DELEGATED DECISIONS BY CABINET MEMBER FOR TRANSPORT MANAGEMENT

GARSINGTON ROAD, OXFORD: ACTIVE TRAVEL SCHEME

Report by Corporate Director for Environment and Place

Oxford: B480 Garsington Road - proposed highway improvements

Figure 2 St Luke's Rd, current situation.

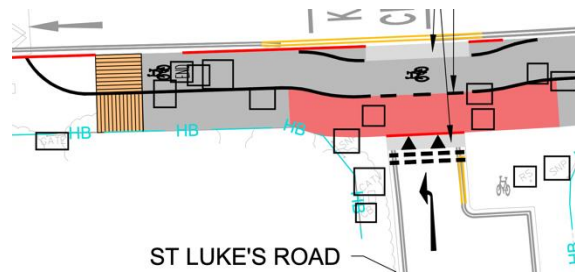
St Luke's Road:

The path re-entry to the carriageway is: -

- too abrupt,
- No dropped kerb is shown, whilst we can see the red line for 'proposed kerbing'.
- The DYLs continue across the cycle path which is not as described in s86 of the Traffic Management Act 2004.¹
- This design is potentially dangerous being located at the point where two westbound lanes begin.
- This is unsatisfactory and we would ask for a protected, that is a physically protected re-entry.
